**APPLICATION AS NOTIFIED**

**(RM210657)**

### **SERVICE OF NOTICE / LIMITED NOTIFICATION**

**RM210657 – REQUEST FOR FURTHER INFORMATION RESPONSE**

ELEVATIONS. 1:100.

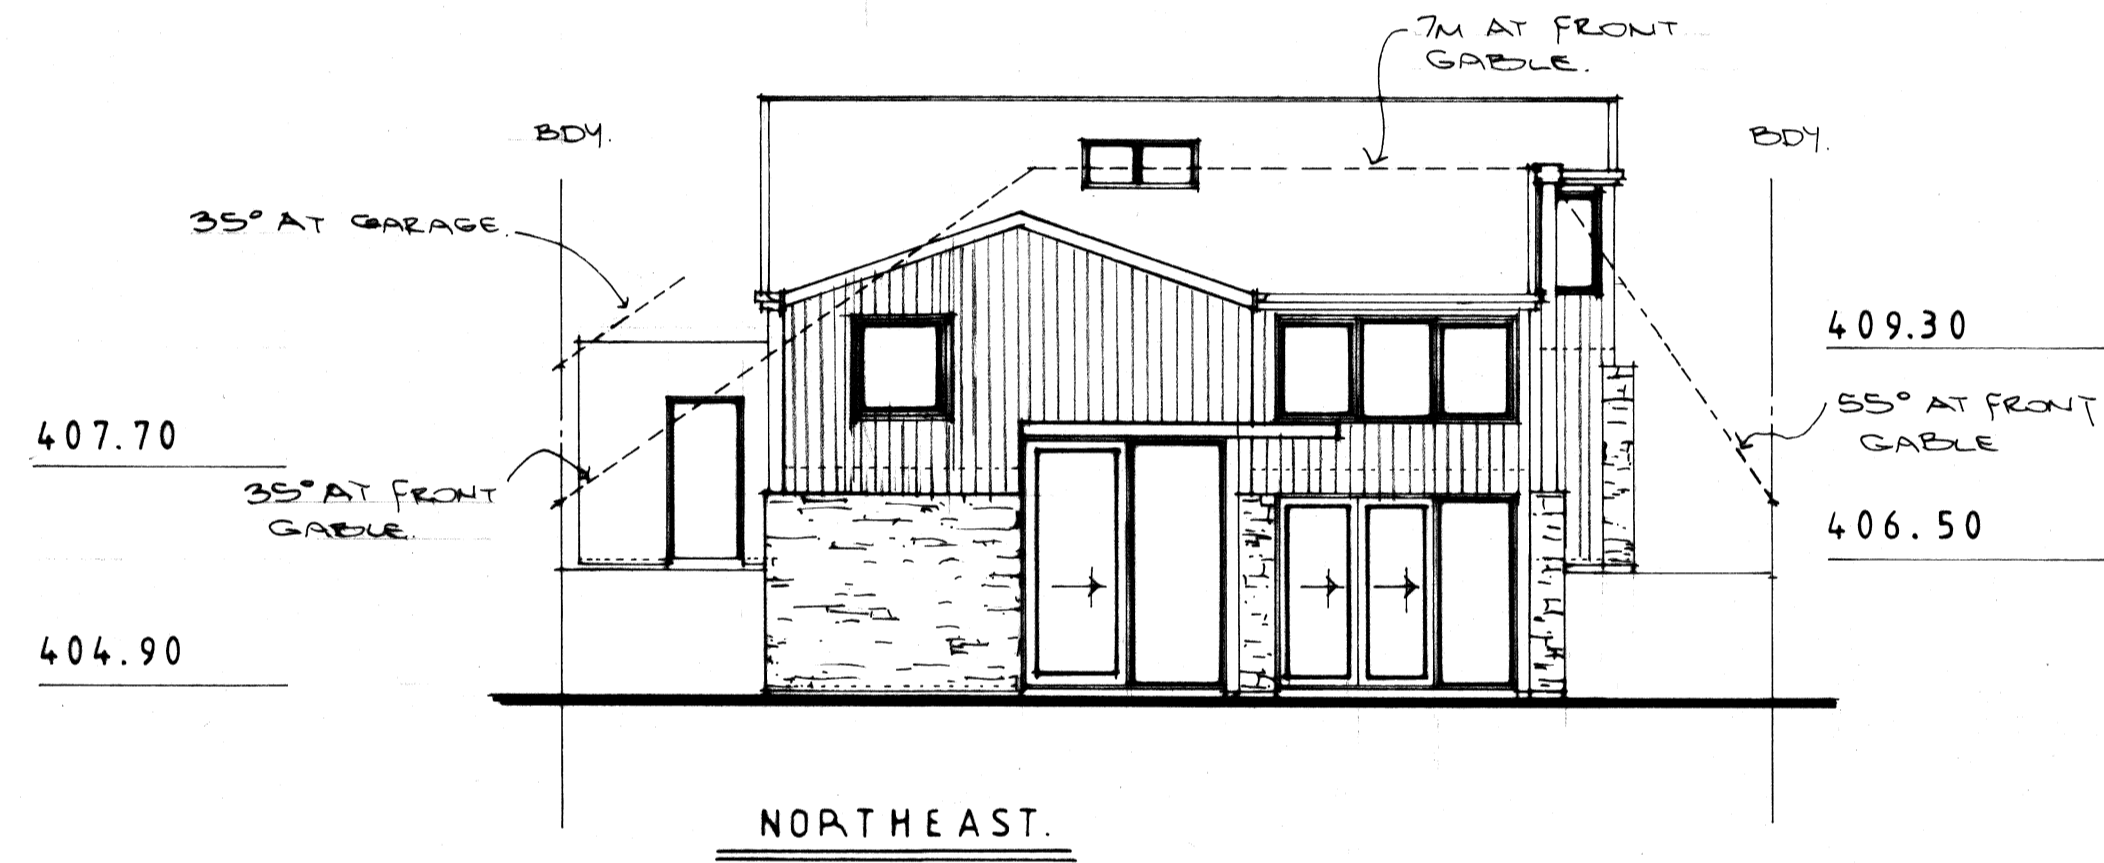
- 5. The AEE states that the garage door will be constructed out of timber boarding stained dark brown but the elevations state it will be Colorsteel. Please confirm which is right and correct the relevant document.*

Figure 1: Area considered to be a residential flat due to tea making facilities/ sink.

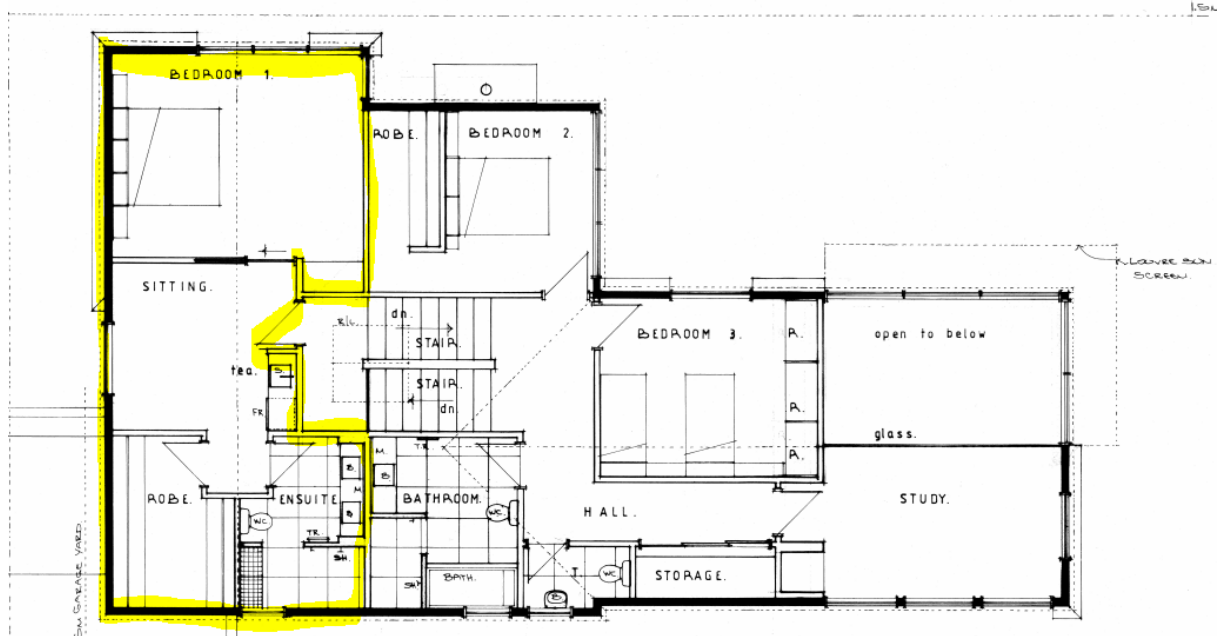
3. Please confirm the extent of the residential flat on the Upper Level Floor Plan and confirm the floor area (in sq m) that is intended to form part of this flat. You can indicate this on the floor plan you have provided.

Residential flats are permitted within this zone and as stated within the AEE, this area cannot be accessed independently (therefore cannot function as a separate household unit). The internal stairs could potentially be counted as part of the main residence and part of the residential flat. The area considered to be a "flat" is shown in Figure 1 below and has a floor area of approximately 52m<sup>2</sup>. The definition of a residential flat within the Proposed District Plan does not state that the flat has to have separate access. Notwithstanding this, no Development Contribution will be levied on the flat as the Development Contributions Policy require flats to be an 'independent residence' (i.e. have separate external access).

EARTHWORKS PLAN. 1:100.

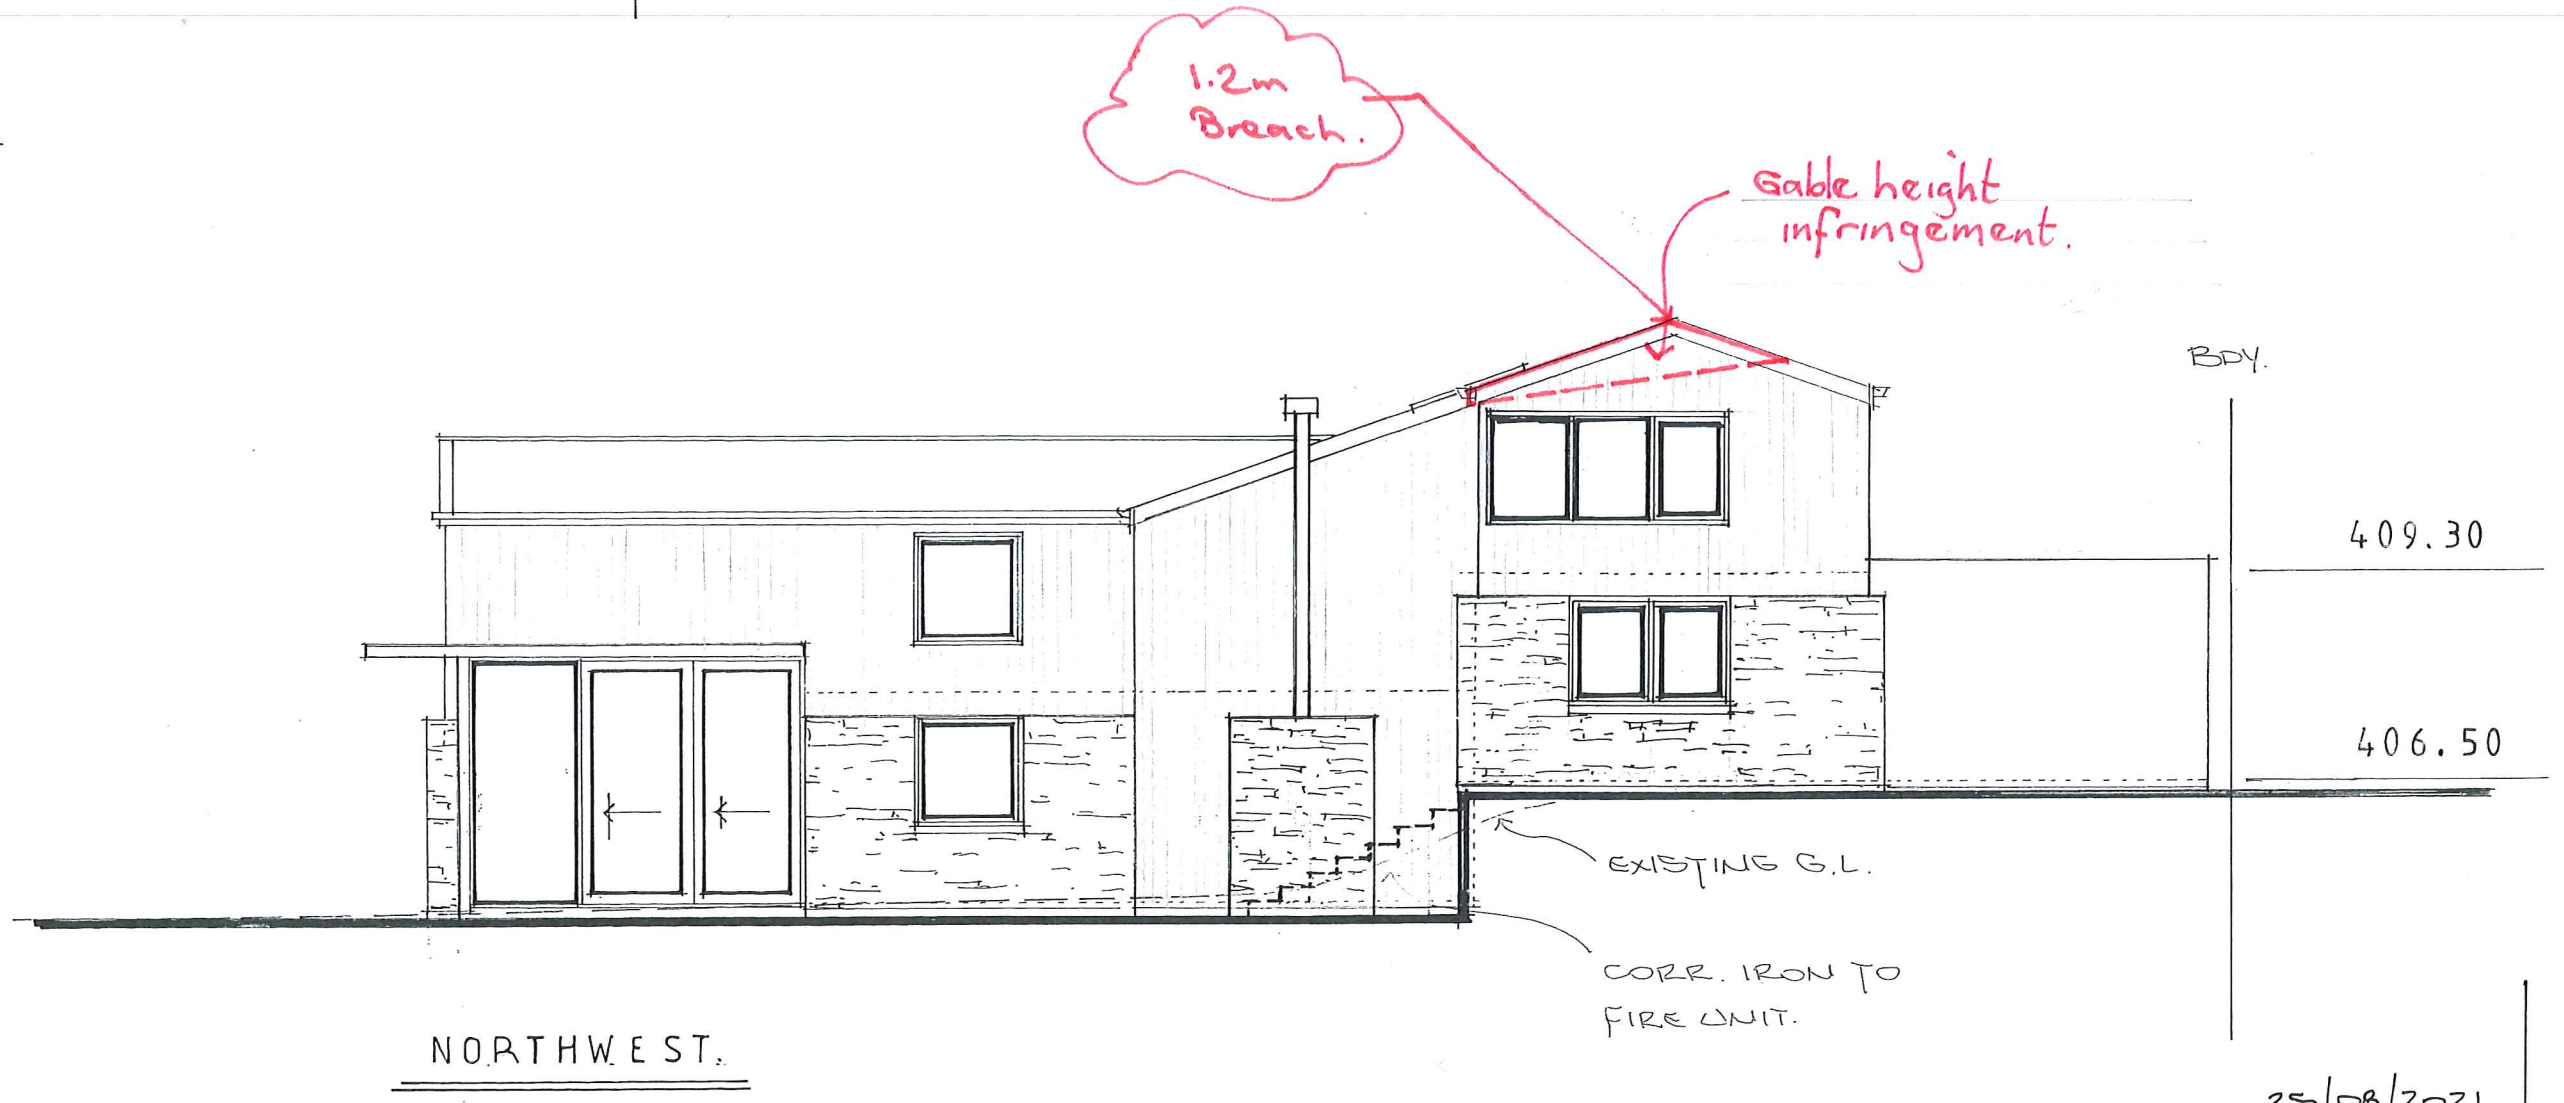
- 2. Please provide an earthworks plan confirming the location, volume and depth of cut and fill required to construct the dwelling and associated curtilage.*

See attached earthworks plan. All earthworks will comply with Proposed District Plan requirements. The total volume of earthworks is 34m<sup>3</sup> which consists of 24m<sup>3</sup> and 10m<sup>3</sup> of cut. The maximum cut will be 0.7 metres and maximum fill height will be 0.8 metres.
